BAR Meeting
March 4, 2015

ISSUE: Permit to Demolish/Capsulate and New Construction

LOCATION: 700-710 North Washington Street

BAR2015-00026 & BAR2015-00027

WYTHE STREET (SOUTH) ELEVATION

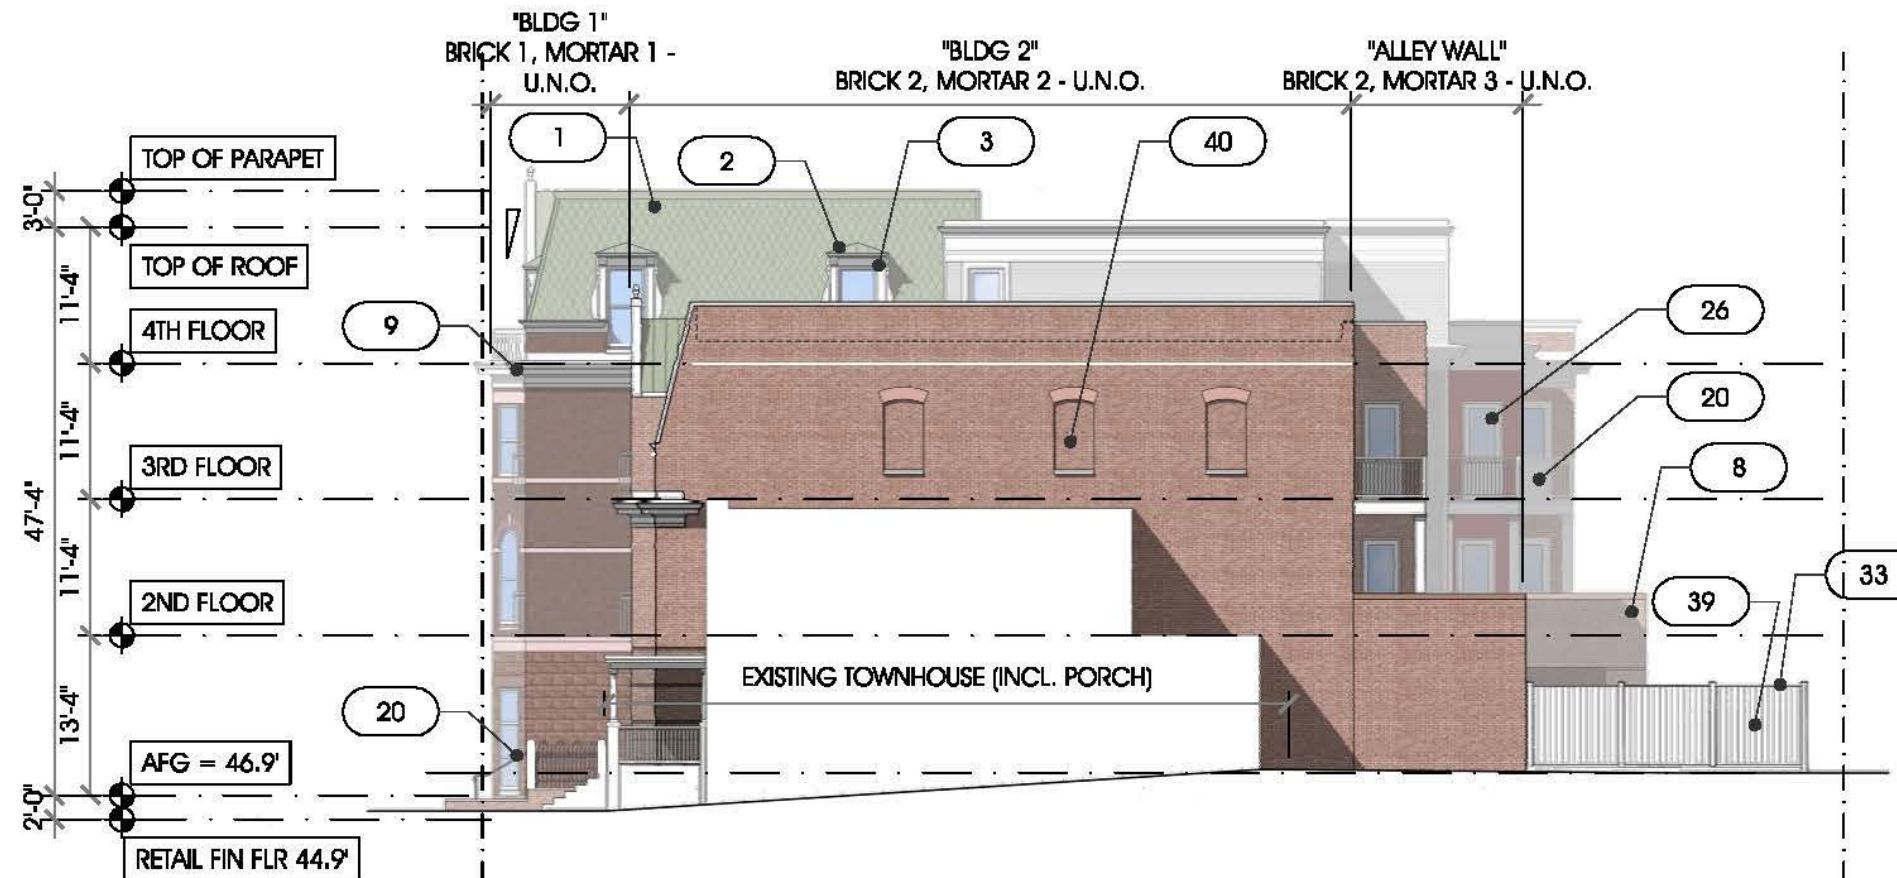
1. Pursue the two story tall bow window alternative shown in the Wythe Street elevation drawings dated February 2, 2015, with a projection of approximately 36" from the building wall. The applicant must acquire approval of an Encroachment from City Council for the bow window before approval of a building permit or must redesign an alternate scheme that does not encroach and return to the BAR for final approval of this elevation.

The concept proposal and current proposal include a pronounced two-story rounded projecting bay, or bow window, onto Wythe Street that is the central design feature of this facade. The depth of the window projection was not specified in the concept review drawings and projections into the City right-of-way are limited to 10" in the City Code. The bay is well-proportioned and a prominent visual feature on this elevation which will also be highly visible from Washington Street. Staff does not believe 10" is adequate and recommends that the BAR require this projection to be increased. Historic bays such as this would typically extend approximately three feet from the building face (see Figures 3 & 4 below). Construction of the bay at the recommended three foot projection will require approval of an encroachment by Planning Commission and City Council.

The applicant has submitted an alternative elevation design for Wythe Street, dated February 26, 2015, that stays within the 10" projection limitation of the Code. However, staff believes this simplified alternative lacks the strong focus of the original design and does not recommend its approval.

ALLEY (WEST) ELEVATION

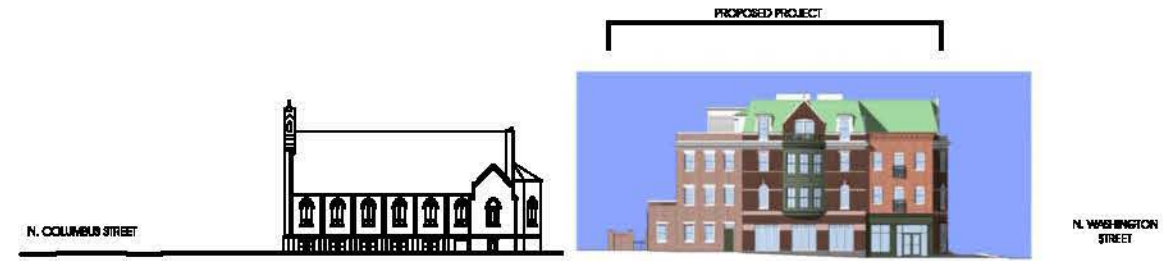
The most significant change to this project has been a reconfiguration of the rear elevations. Figure 1 shows the previous rear (west) elevation shown to the BAR at concept review. As the

design has evolved since that time, the applicant has reconsidered unit layout and the desire to add outdoor space in the form of balconies and terraces. Figure 2 shows the proposed rear elevation. The current rear elevation is less massive and less formally composed than what was previously proposed. The scale is broken down and it has a strong set back above the third story, providing a better transition to St. Joseph's Catholic Church to the west. The previous concept version had an awkward roof line as the mansard changed planes and turned corners and had a large, bland masonry wall surrounding the parking garage and loading bays. The current rear elevation also introduces simpler forms and materials, typical of secondary elevations on both new and old buildings, and features greatly increased articulation of the building mass. Additionally, the rear now offers balconies and terraces as well as more refined brickwork along the alley for the garage and loading areas. This alley façade is visible from both Wythe Street and the play yard at the adjacent Church. Staff has no objection to the changes to the rear elevation and finds the current proposal to be a substantial improvement, representing appropriate changes and refinements from concept review to Certificate of Appropriateness final review.

WYTHE STREET ROOF EQUIP SIGHT LINES

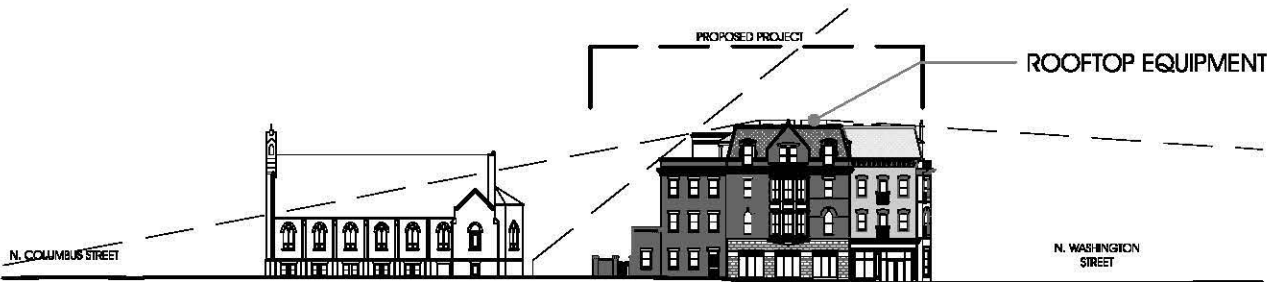
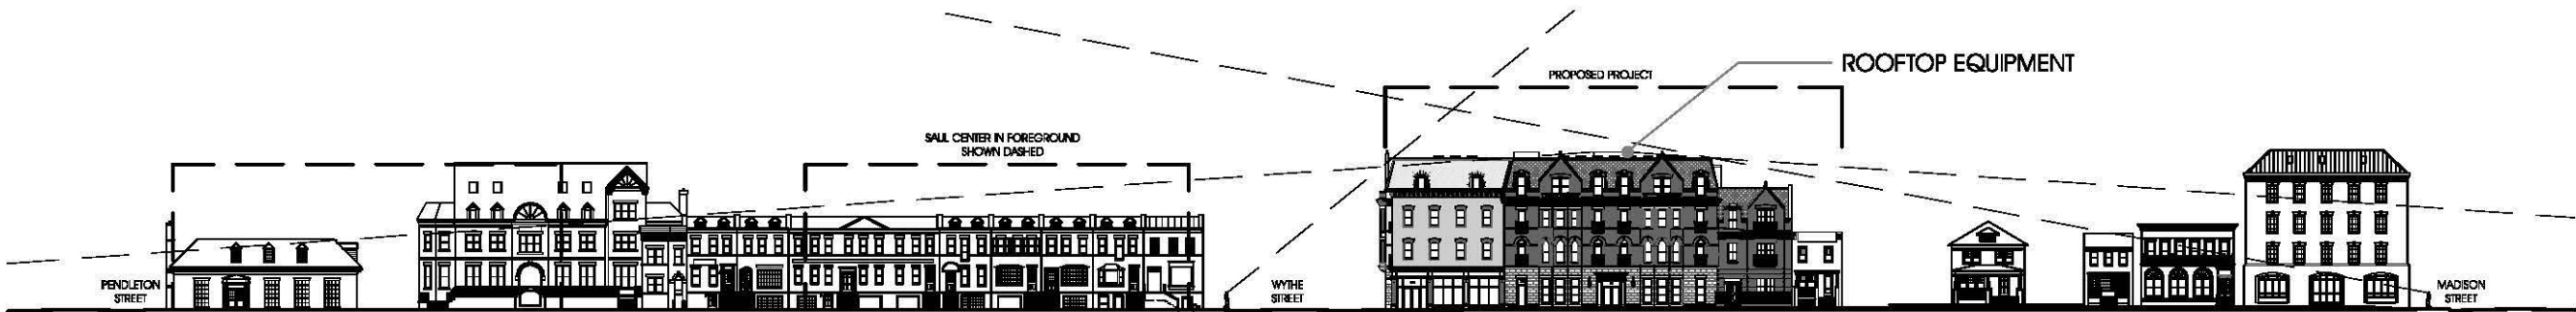
The applicant has provided sight lines showing that the proposed rooftop equipment will be minimally visible. The proposed rooftop equipment will be located near the center of the roof and there will be a parapet for much of the roof. Therefore, staff supports the request for a waiver of rooftop mechanical screening with final unit locations to be confirmed by staff on construction drawings and in the field.
